## Development Permit Panel

1. **Development Permit 14-669686**  
(REDMS No. 4549394 v. 2)

2. **Development Permit 14-676613**  
(REDMS No. 4601574 v. 3)

**Development Permit Panel  
Wednesday, June 24, 2015**

1 West Elevation  
1/8" = 1'-0"

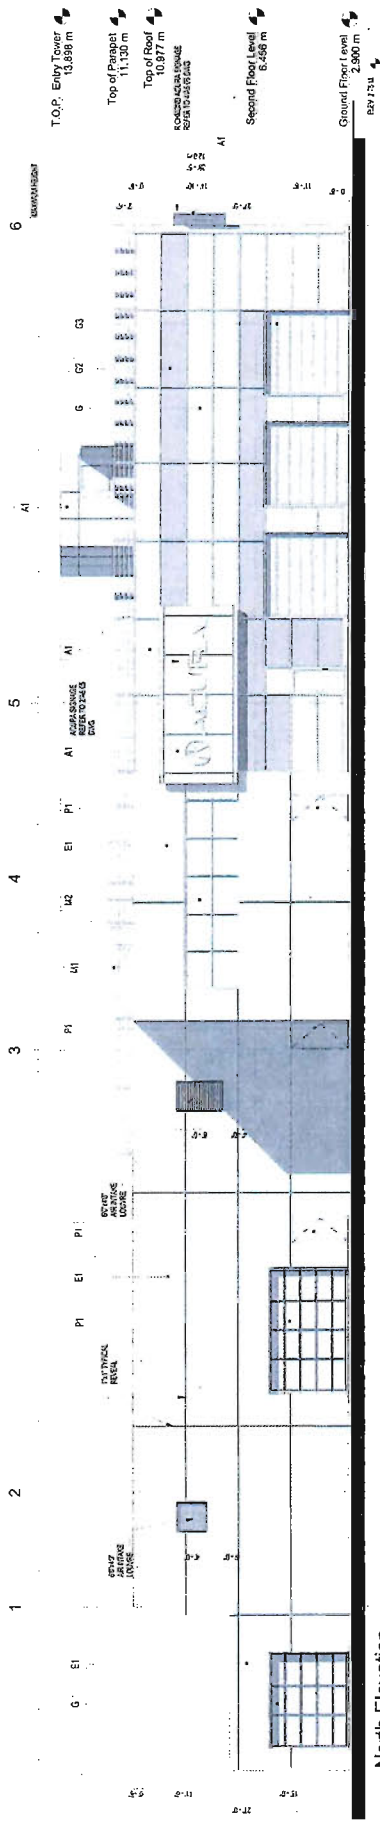
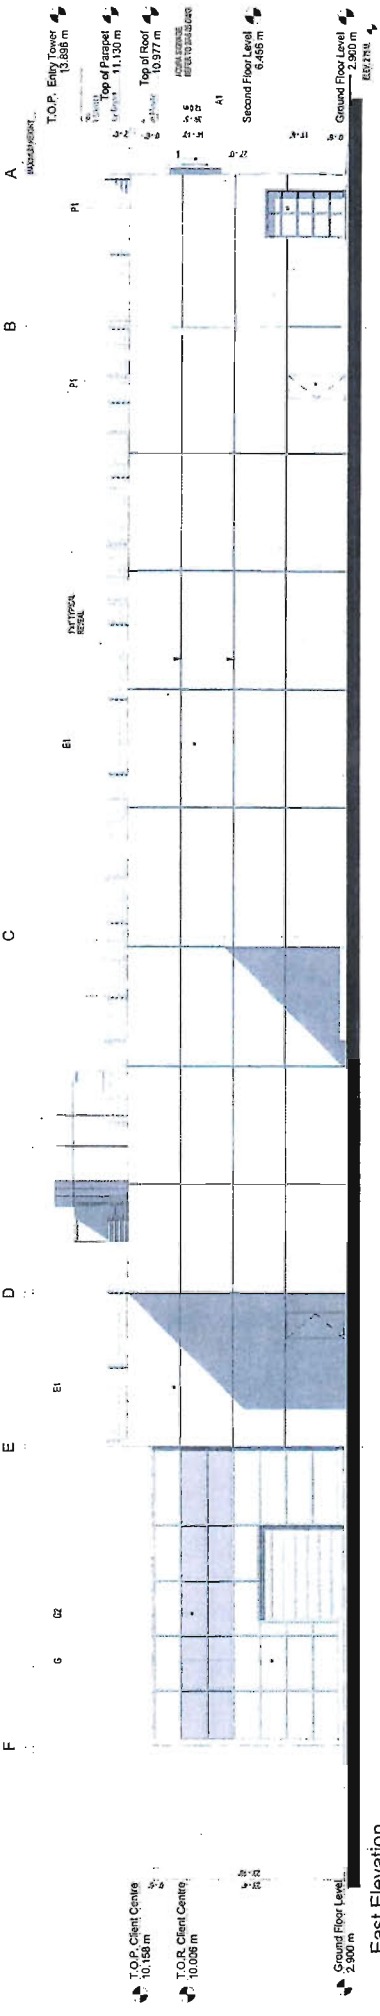
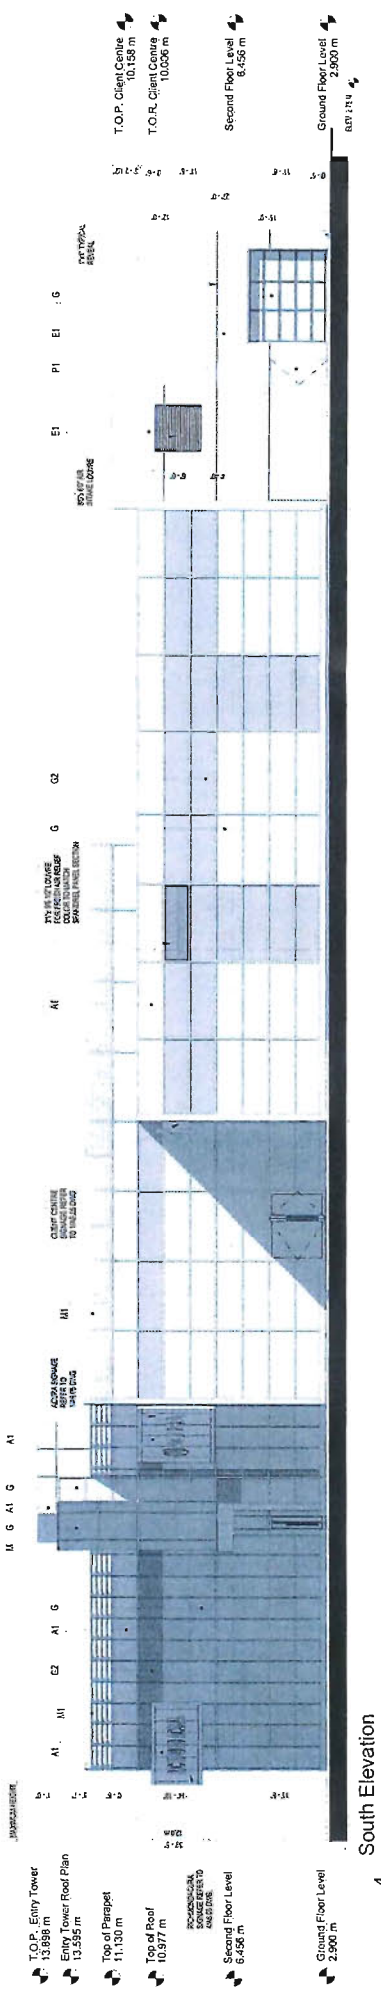
*Low E coating noted on sheet A3.01. Refer to item G on the material and color legend. The top two panel sections in the showroom area and the top three panel sections in the client car center area are opaque metal panels or spandrel panels sections that are intended to reduce solar gain in the summer.*
